<b>DOCKETED</b>	
<b>Docket Number:</b>	19-SPPE-04
<b>Project Title:</b>	SJ2
<b>TN #:</b>	239411
<b>Document Title:</b>	SJC Data Center SPPE Application Supplemental Filing Appendix 1D Part 1
<b>Description:</b>	N/A
<b>Filer:</b>	Jerry Salamy
<b>Organization:</b>	Jacobs
<b>Submitter Role:</b>	Applicant Consultant
<b>Submission Date:</b>	8/20/2021 4:42:06 PM
<b>Docketed Date:</b>	8/20/2021

**Appendix 1D**  
**Revised Supplement in Track Changes**

Microsoft Corporation (Applicant) proposes to construct and operate the San José City Data Center SJC (SJC02) located at 1657 Alviso-Milpitas Road in San José, California. The ~~SJC02SJC~~ will consist of two single-story data center buildings. The expected electrical load of the project is ~~92-77~~ megawatts (MW), inclusive of information technology (IT) equipment, ancillary electrical/telecommunications equipment, and other electrical loads (administrative, heat rejection, and safety/security). The Applicant will stipulate in an agreement with the utility to a contractual limit in amount of electricity available from Pacific Gas and Electric's (PG&E's) system to a maximum of 99 MW.

**Figure 2-1R**  
**Site Plan**  
 San José Data Center (SJC02)  
 San José, California

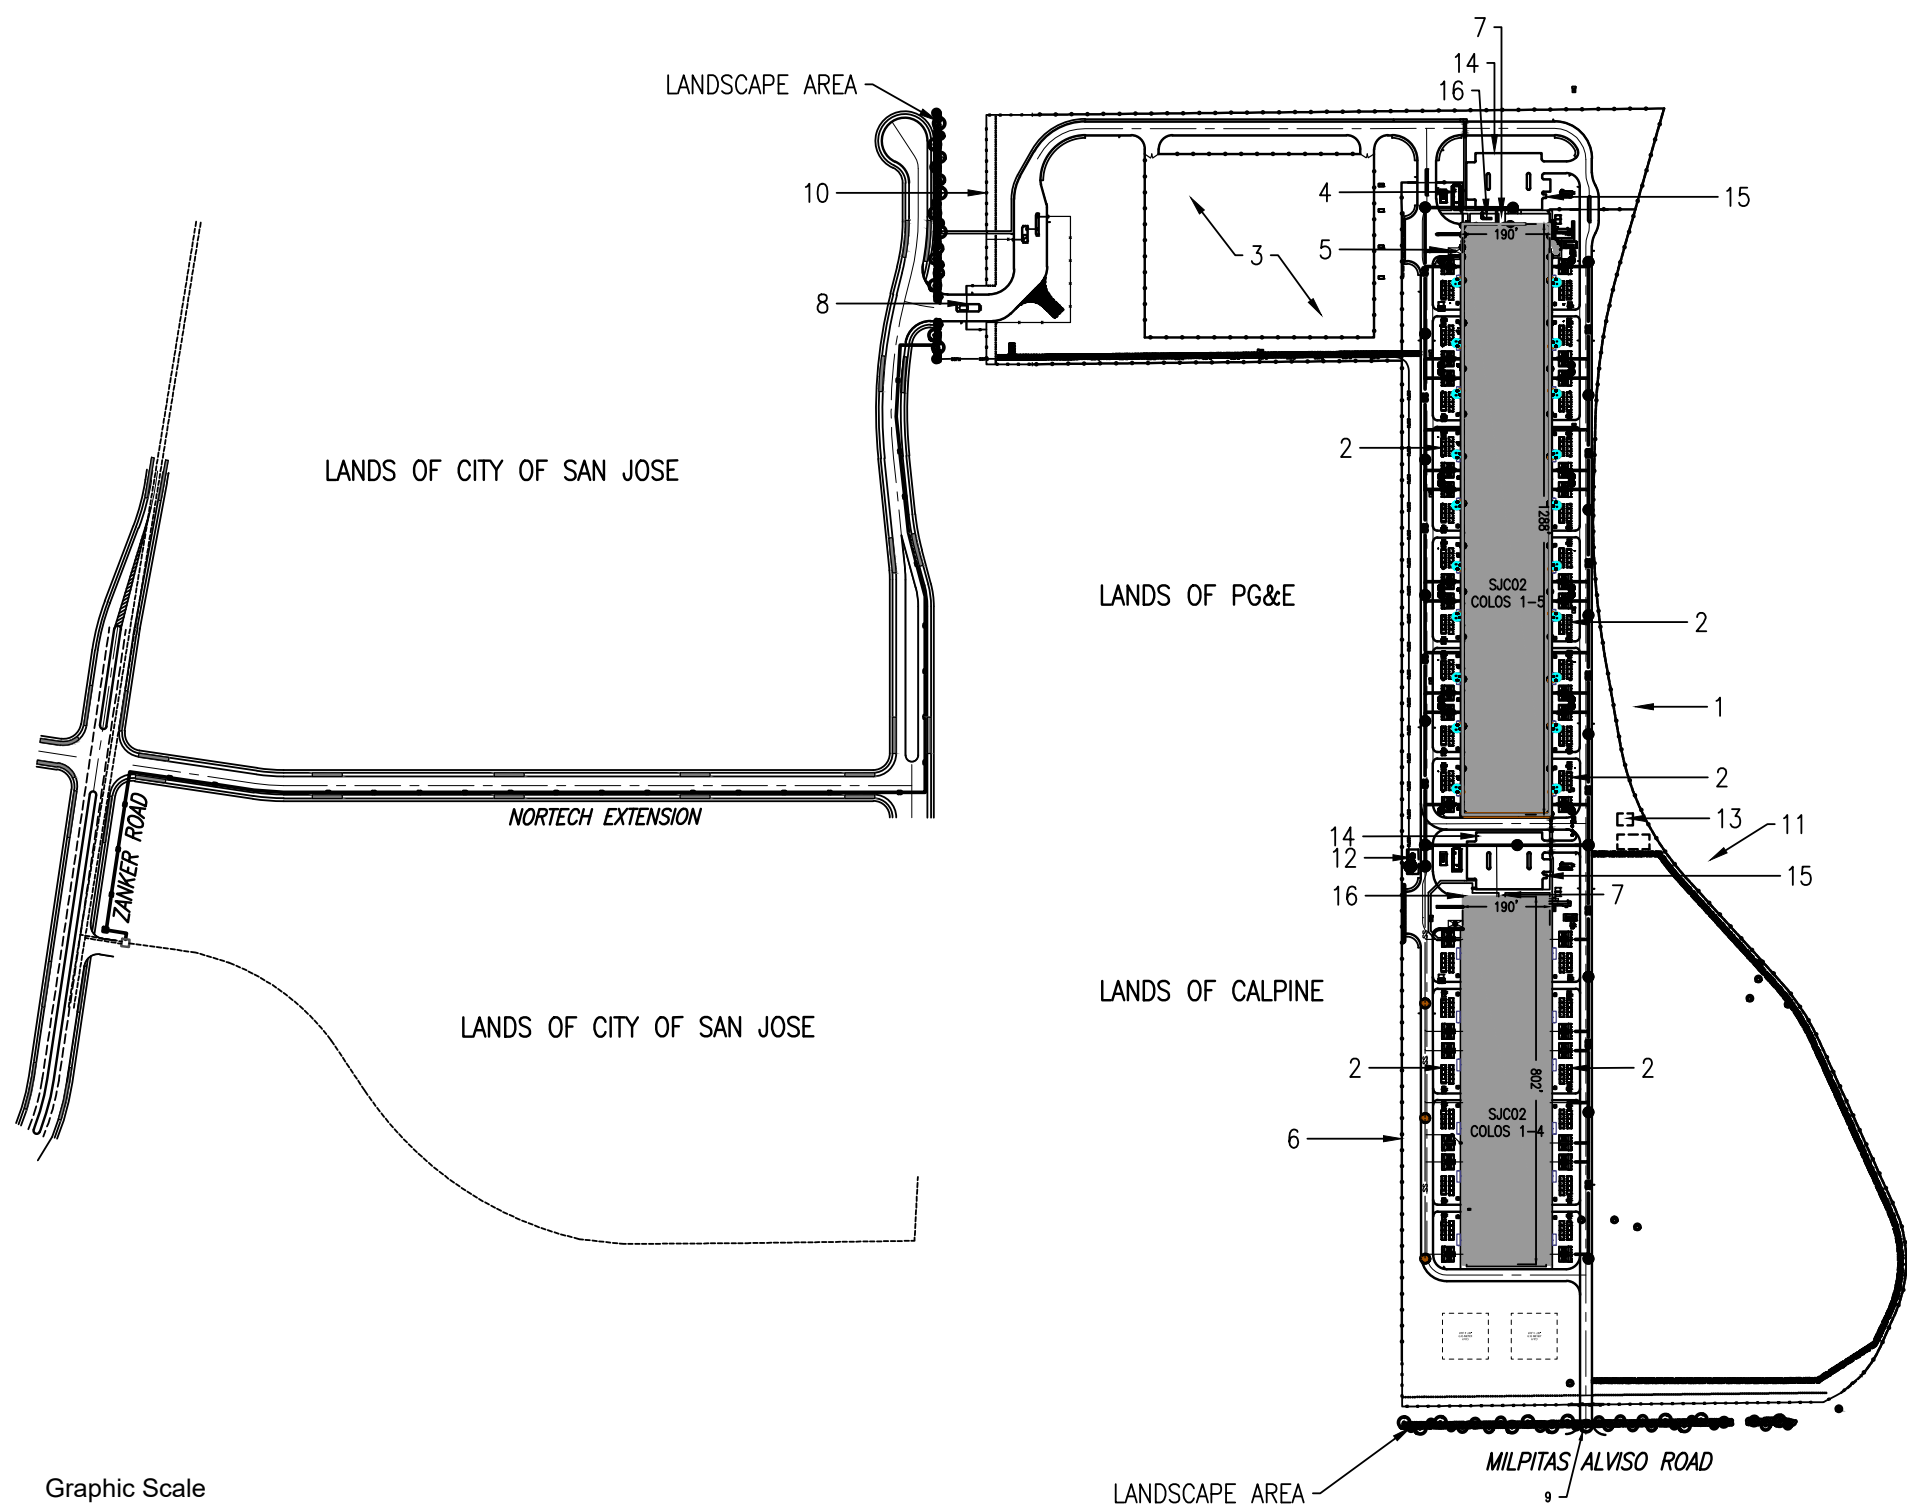
The SJC02 consists of two buildings with approximately ~~4793967,914000~~ gross square feet of administrative and data center space. The northern building (designated SJC02) is a single-story structure of approximately ~~244244,705-676~~ gross square feet ~~consisting of 5 colocation units (-colos)~~ with supporting amenities. The southern building (designated SJC03) is a single-story structure of approximately ~~237,268152,238~~ square feet ~~consisting of 3 colos~~ with supporting amenities. Both buildings include ~~13,826 square feet~~ administrative ~~spaceareas, including~~ restrooms and shower facilities, storage areas, ~~and~~ loading docks. ~~The site includes, backup generator yards,~~ stormwater bio-swales, paved surface parking lots, and landscaping features. ~~SJC02-The site~~ also includes an onsite ~~230115~~-kilovolt (kV) substation with two, ~~underground 230115-kV~~ electrical supply lines that will connect to PG&E's Los Esteros Substation, located adjacent to the site. The approximately 64.5-acre ~~p~~Project site (~~Assessor's Parcel No. 015-31-054~~) is designated Light Industrial under the adopted Envision San José 2040 General Plan; is identified as Light Industrial in the applicable Alviso Master Plan; and is zoned LI- Light Industrial ~~with an Assessor's Parcel Number of 015-31-054~~. Figure 1-1 shows the regional location of the SJC02 site, and Figure 1-2~~R~~ identifies the project site location. A site plan is provided as Figure 2-1~~R~~.

The standby generation system for the project consists of ~~40-224 renewable 3.0-MW diesel-natural gas-fired~~ generators, each with a standby output capacity of ~~30.045~~ MW to support the need for the data center ~~uses~~ to provide an uninterruptible power supply. ~~The SJC -Each building's~~ administrative functions will be supported during electrical outages by ~~a-two~~ standby generators (designated as Admin generators), with a 1.25-MW ~~diesel-fired~~ standby generator for the northern building and a 0.5-MW standby ~~diesel-fired~~ generator for the southern building. Additional project features include electrical switchgear and ~~subsurface~~ distribution lines between the substation and buildings, as well as from the backup generators ~~yards~~ and from each respective building. The backup generation system will be located ~~in-equipment yards~~ along the sides of each building. ~~Each-The SJC02 building~~ will include ~~21-141~~ standby generators (~~20-140 30.448-MW standby-natural gas~~ generators and an Admin standby

Figure 2-6R  
Interconnection to PG&E System  
and One Line Diagram  
San José Data Center (SJC02)  
San José, California

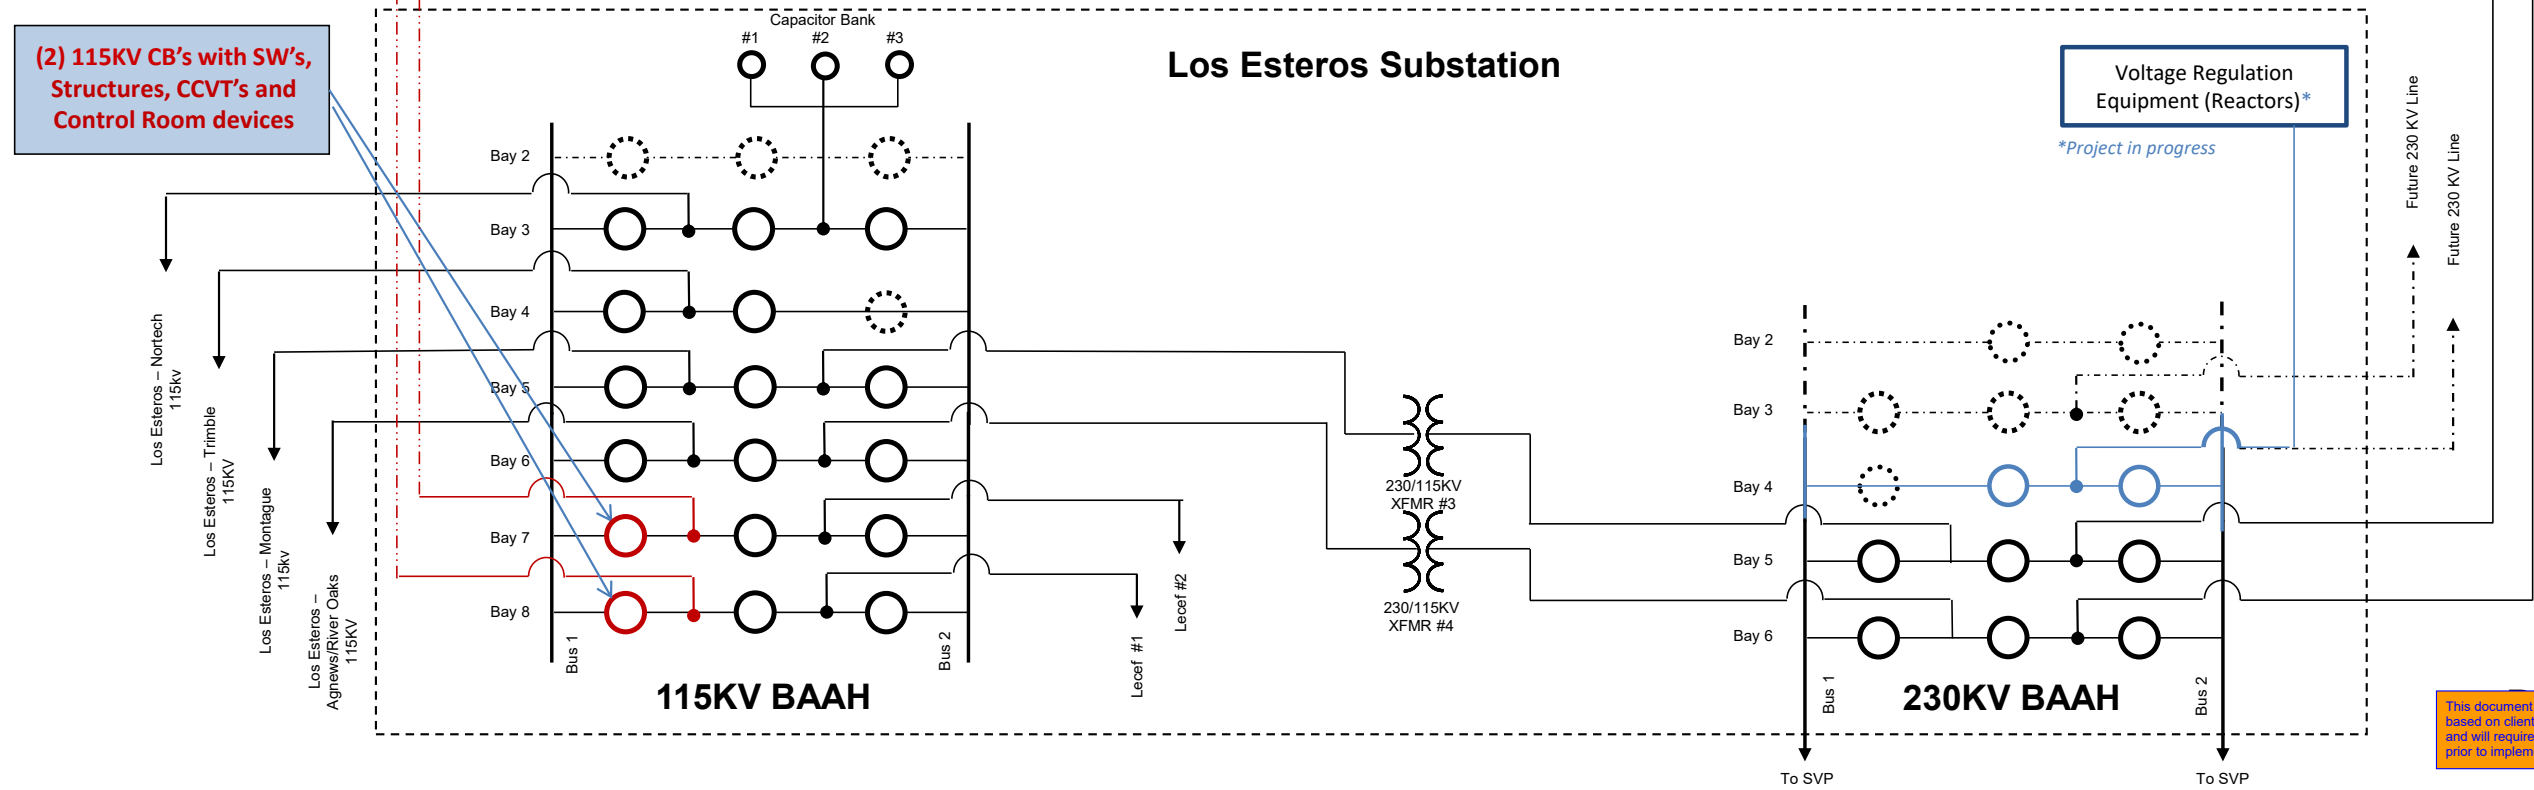
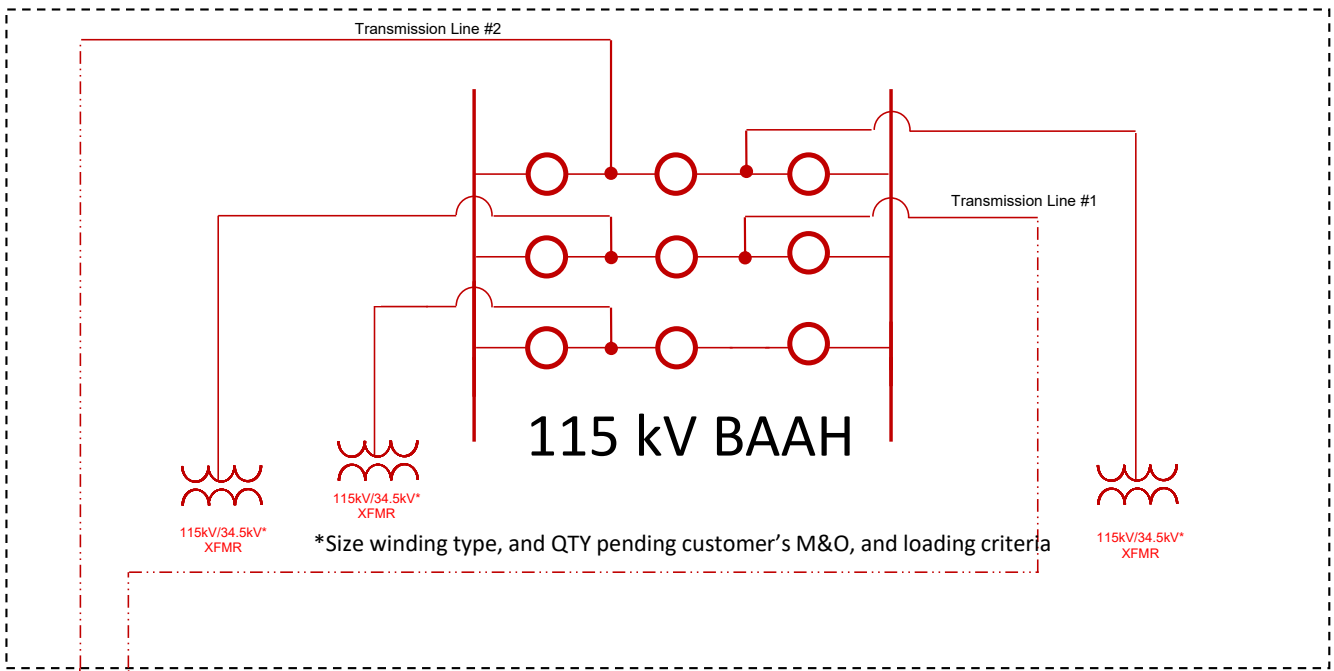
The two separate 230115-kV PG&E distribution lines are connected to PG&E's Los Esteros substation at two new, separate circuit breakers (Bays 7 and 8). The interconnection to the PG&E System and One Line Diagram is provided as Figure 2-6R. The SJC02 distribution lines will include 1,250 kcmil copper XLPE extruded dielectric cables capable of transmitting 150 Mega Volt Amps. a 715 double bundle
